**IN THE DRAWINGS:**

## REMARKS

### Amendments To Drawings

FIG. 1

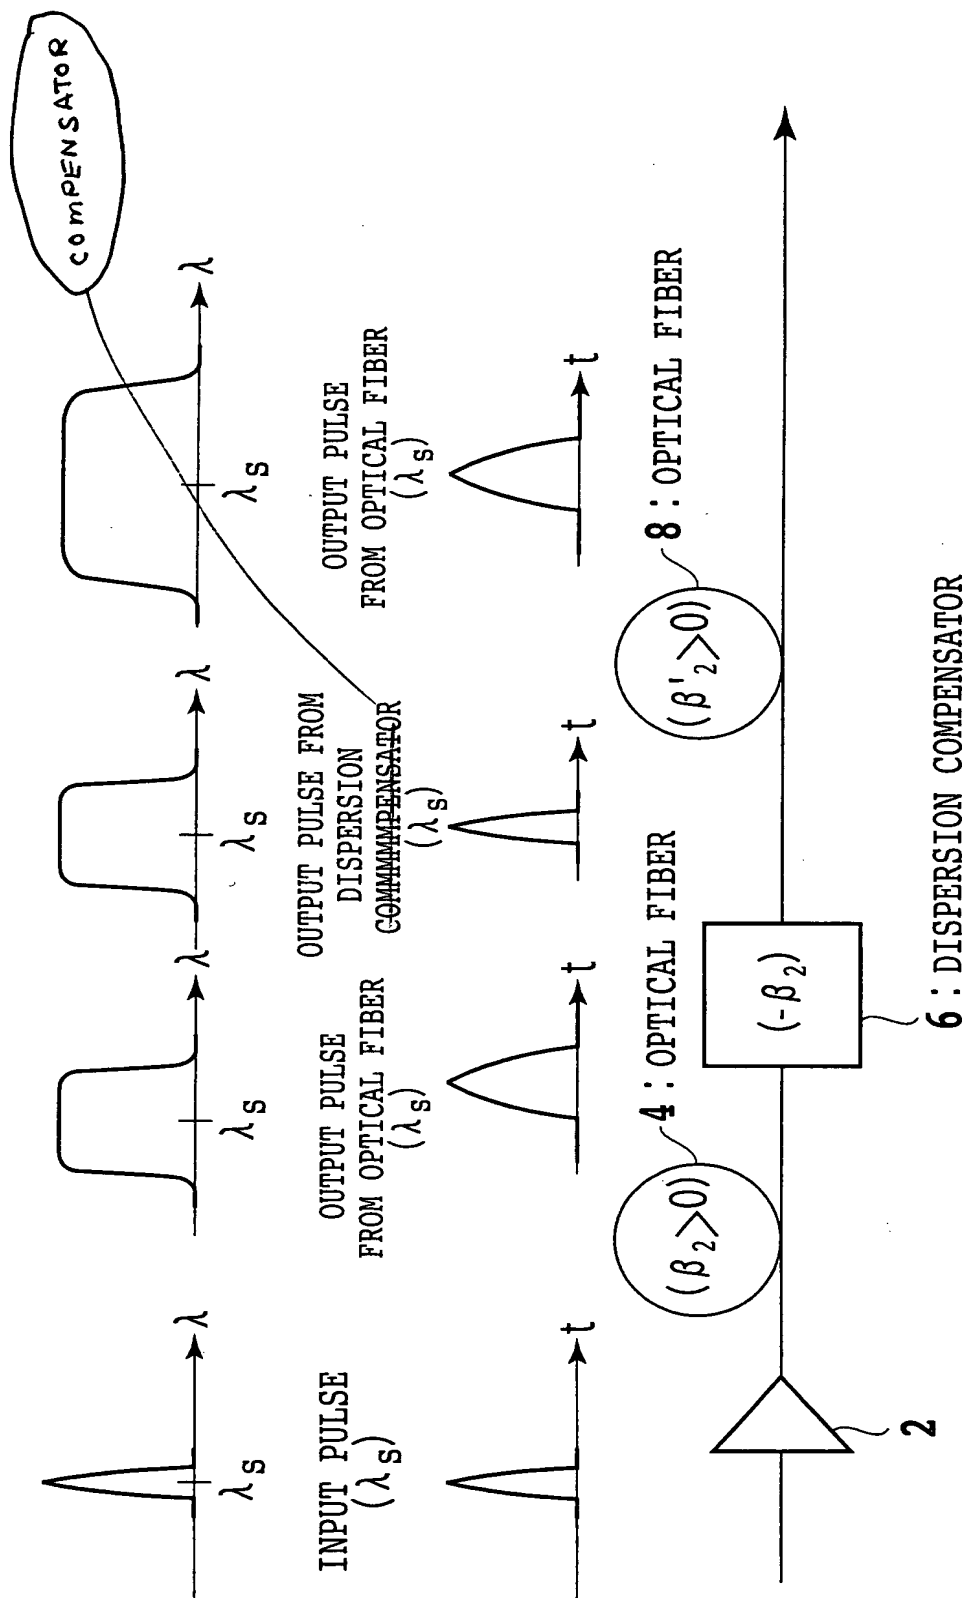
In FIGs. 1, 3, and 4 the term "COMMMMPENSATOR" is replaced with the term --COMPENSATOR--. In FIG. 4, the labeling for amplifier "48" is replaced with --52--.

FIGs. 1, 3, and 4 are amended to correct the spelling of the term --COMPENSATOR--. FIG. 7 is amended to correct an informality and label correctly label amplifier "48" as amplifier --52--. Support for the amendment is found on page 26, lines 10-11 that refers to FIG. 7 o "optical amplifier 52. No new matter is being presented, and approval and entry are respectfully requested.

In item 1 of the Office Action, the Examiner objects to the drawings because of the misspelling of the word "compensator" in FIGs. 1, 3, and 4. (Action at page 2).

In FIGs. 1, 3, and 4, the term "COMMMMPENSATOR" is replaced with the term --COMPENSATOR--. Reconsideration and withdrawal of the objection to the drawings are respectfully requested.
